# PREVOST

## WARRANTY BULLETIN

Wb10-29

| SUBJECT : REPLACING TAG AXLE HUB CAP SCREWS |                                   |

CAP SCREWS 5001842 QTY 14 / SIDE  
TORQUE TO 179 LB-FT (243 Nm)

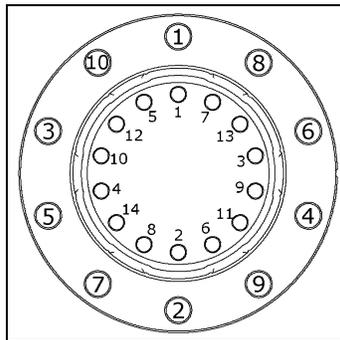
Replace 28 cap screws fixing tag axle hubs (14 on each side). Torque tighten to 179 Lb-Ft (243 Nm).

To avoid hub movement, replace and tighten cap screws one at a time. Replace and tighten cap screws using tightening sequence or one after another in a clockwise manner.
